INCREMENTAL CHANGE

Release Notification Date: 02/13/2024

SPM 70-47-04 ROTARY FLAP PEENING

IC 70-47-04-015 SPM 70-47-04 ROTARY FLAP PEENING

Figure 7 "A" Test Strip Magnetic to Stripholder Arc Height Conversion Graph

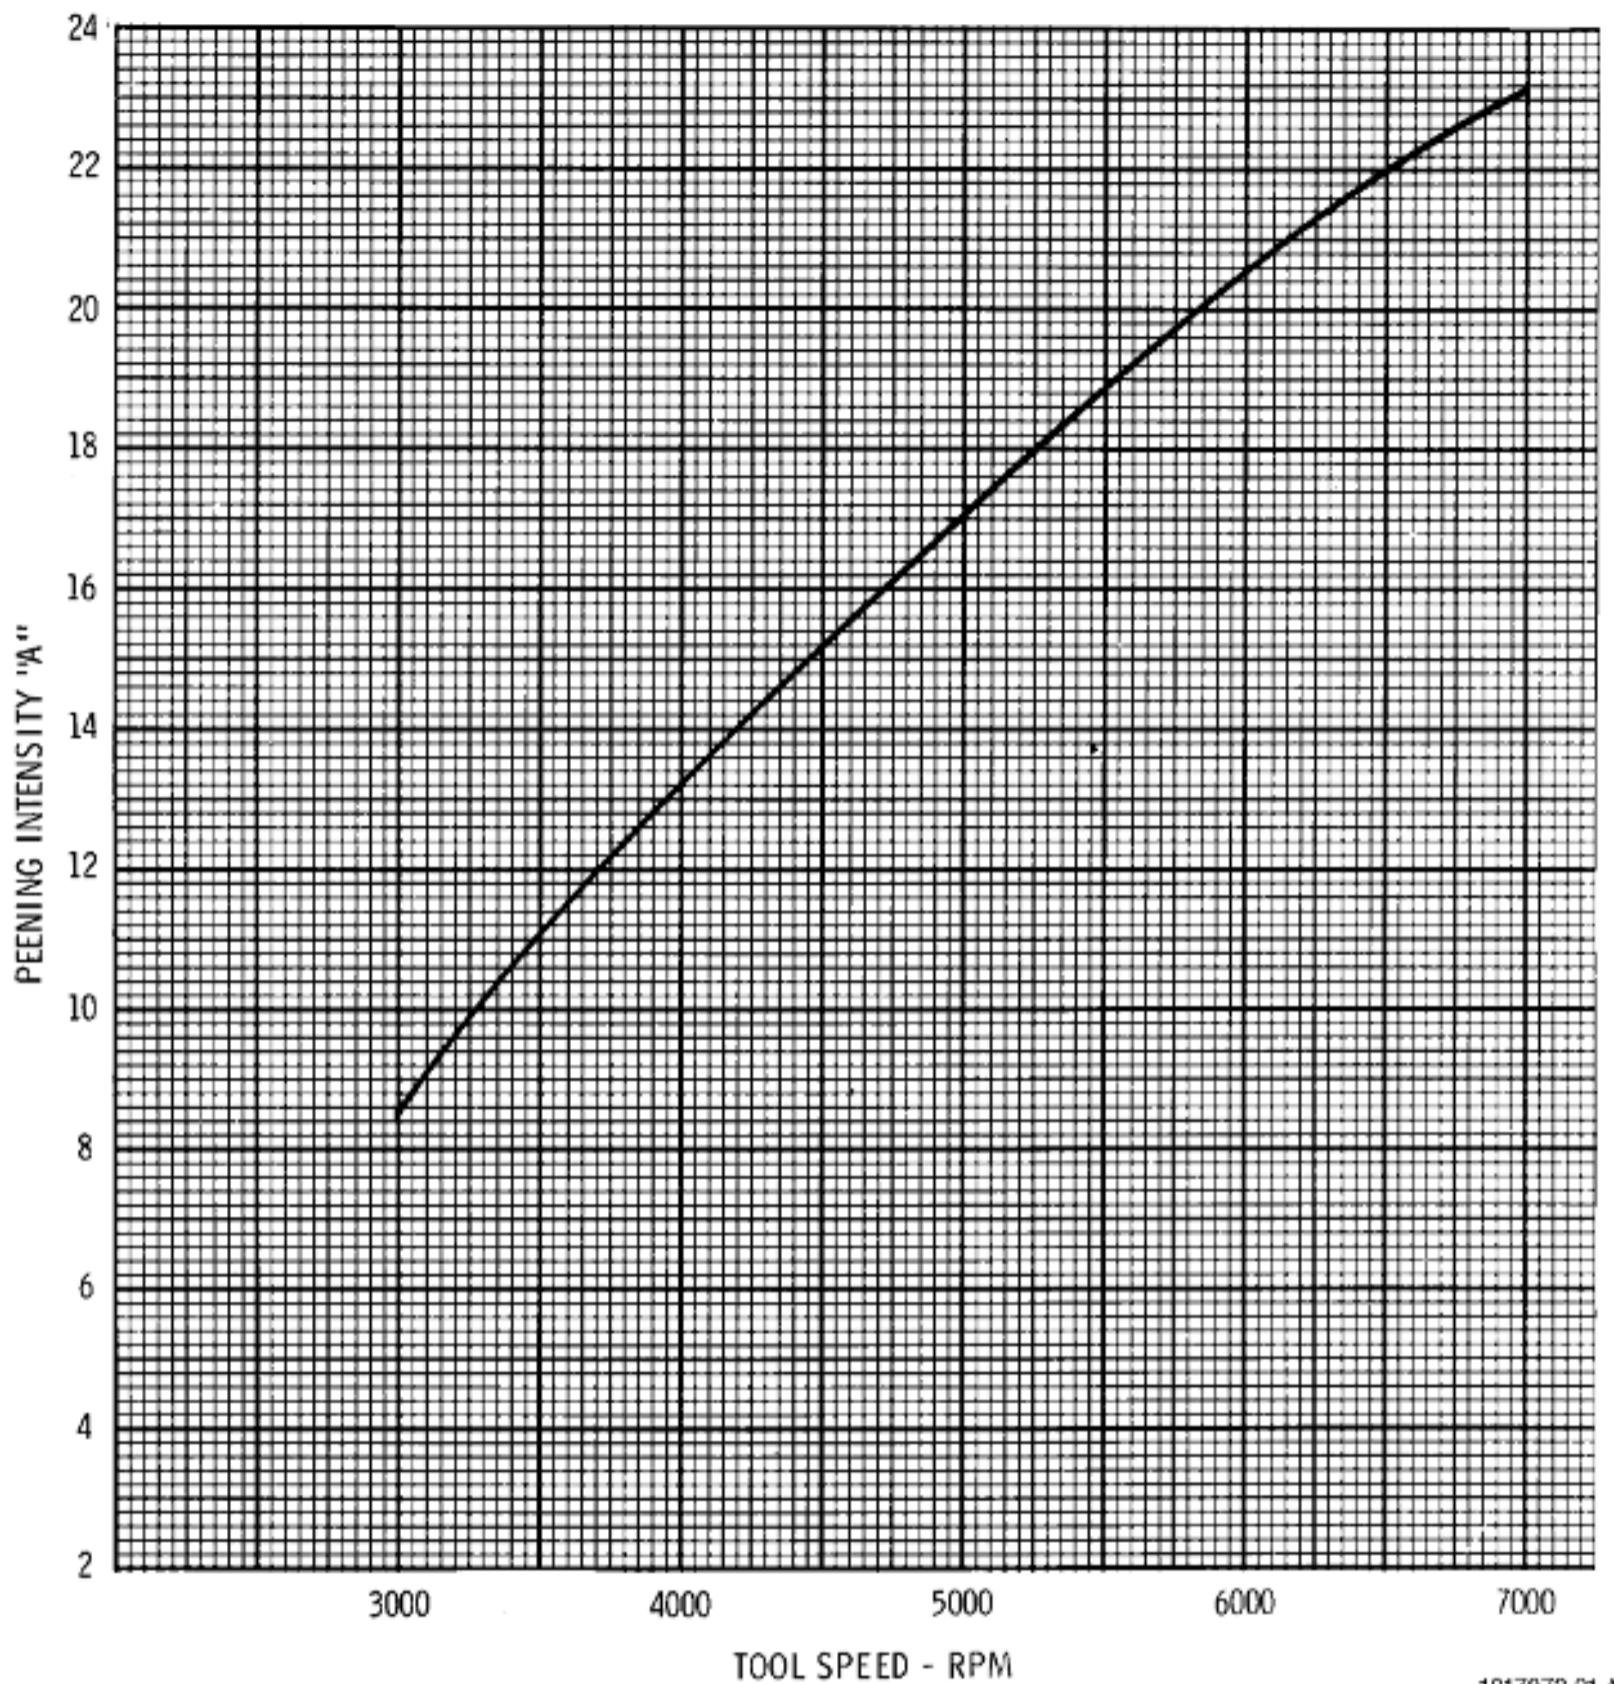
- sk70-47-04-380-195 [Technical Change: Changed procedure to do a determination of peening requirements. Also, changed the applicable figure.](#)
- tk70-47-04-380-019 [Technical Change: Changed General information section of the Rotary Flap Peening procedure.](#)

- (1) Convert the required arc height in the Engine/Shop Manual. Use the conversion graphs/tables that follow:
 - (a) For type A Almen test strips use [Figure 7](#) or [Figure 8](#).
 - (b) For type N Almen test strips use [Figure 9](#) or [Figure 10](#).

NOTE: Conversion of strip arc heights is necessary since the Almen strip bends more when using the magnetic Almen strip holder than with the SAE J442 strip holder.
